POWER PLANT - EEC CHANNEL 'A' HARNESS (LOOM A) - INTRODUCTION OF REVISED CLIPPING OF
EEC HARNESS - CATEGORY CODE 7 - MOD.ENG-71-0180

V2500-ENG-71-0180

SERVICE BULLETIN

View on clipping point CP2426 - Before and after change
Fig.1

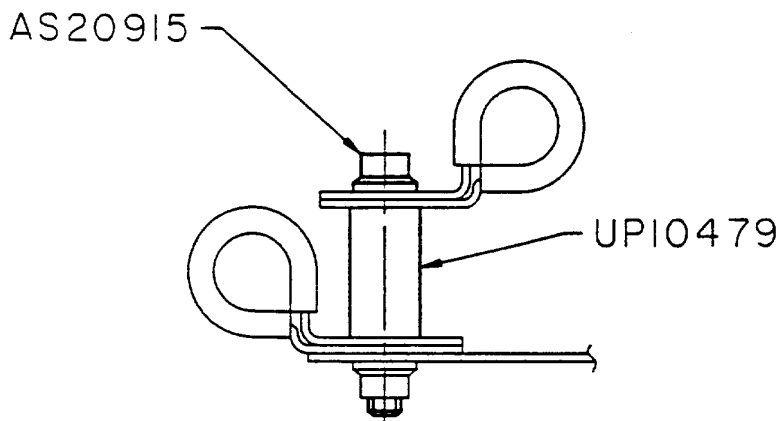
Insufficient clearance can exist between the head of the bolt securing clipping point 2426 and the Fancase EEC Loom A Harness assembly.

(1) The changes introduced by this Service Bulletin at clip point 2426, are as follows:

- (a) A revised bolt is introduced similar to the existing item except for an increase in length.
- (b) An additional spacer is introduced.
- (c) A revised clip is introduced similar to the existing item except for a reduction in size.

VIEW ON CLIPPING POINT 2426
BEFORE ALTERATION.

VIEW ON CLIPPING POINT 2426
AFTER ALTERATION.
